EPC STORMWATER REVIEW COMMENTS IN ORANGE BOXES WITH BLACK TEXT

Grandview Reserve Phase 3 Preliminary Drainage Report

March 2024

HR Green Project No: 201662.203

Pond_C_PH3, Outlet Structure 2/29/2024, 1:47 PM

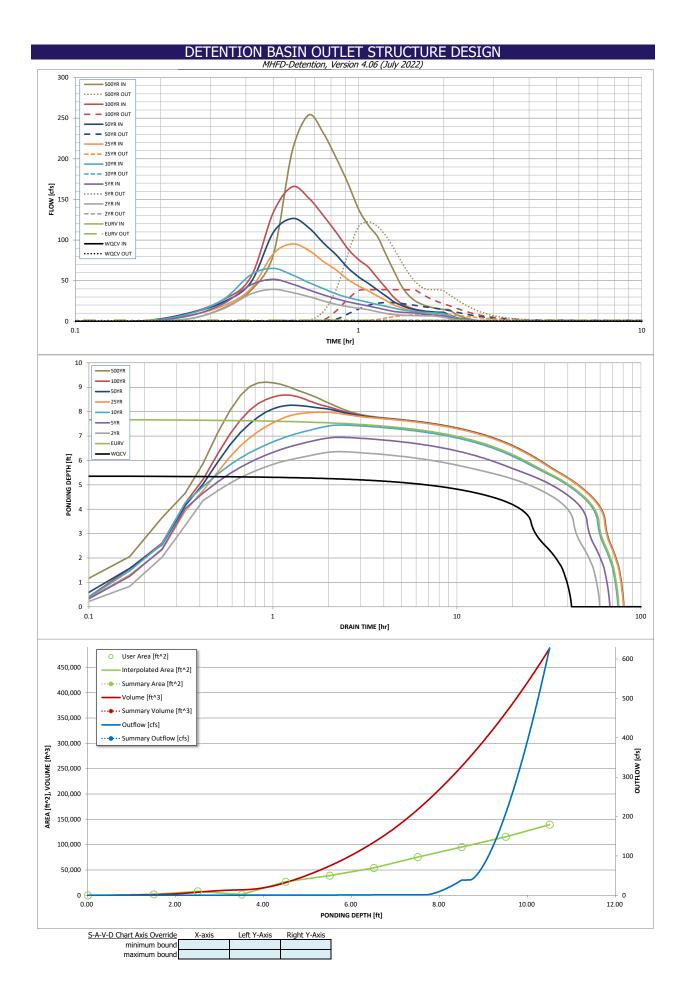
For the Final Drainage Report, please discuss this increase and/or adjust pond design to get this closer to 1. Ok as is for the PUDSP.

Pond_F, Outlet Structure 2/29/2024, 1:28 PM

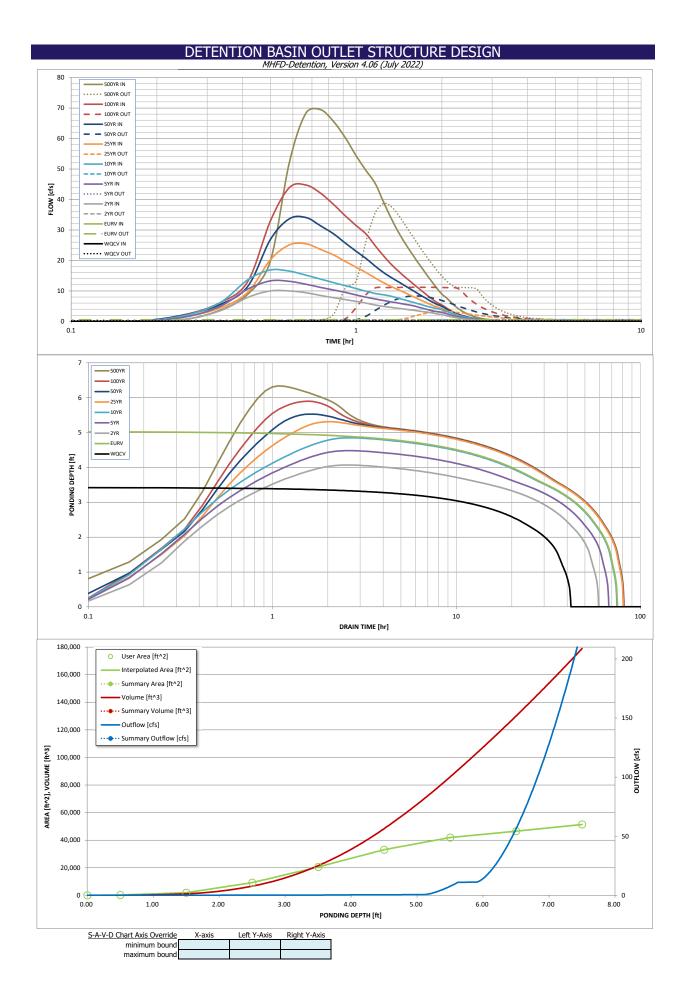
For the Final Drainage Report, please discuss this increase and/or adjust pond design to get this closer to 1. These all should be red, was the spreadsheet modified? Ok as is for the PUDSP.

Pond_REX, Basin 2/29/2024, 12:34 PM

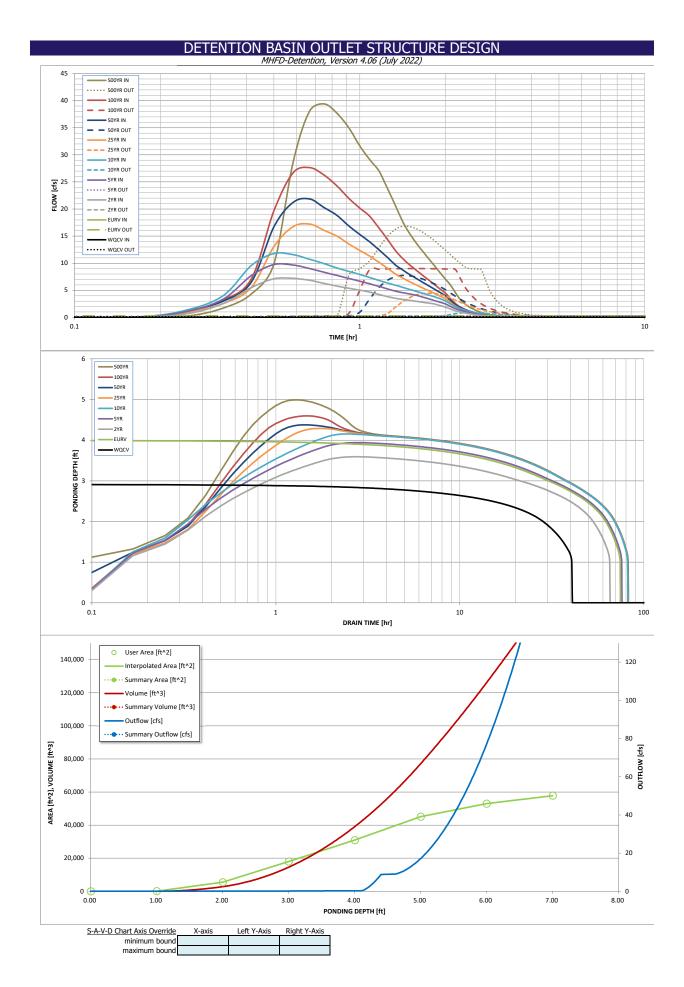
> For the Final Drainage Report, please discuss this increase and/or adjust pond design to get this closer to 1. These all should be red, was the spreadsheet modified? Ok as is for the PUDSP.
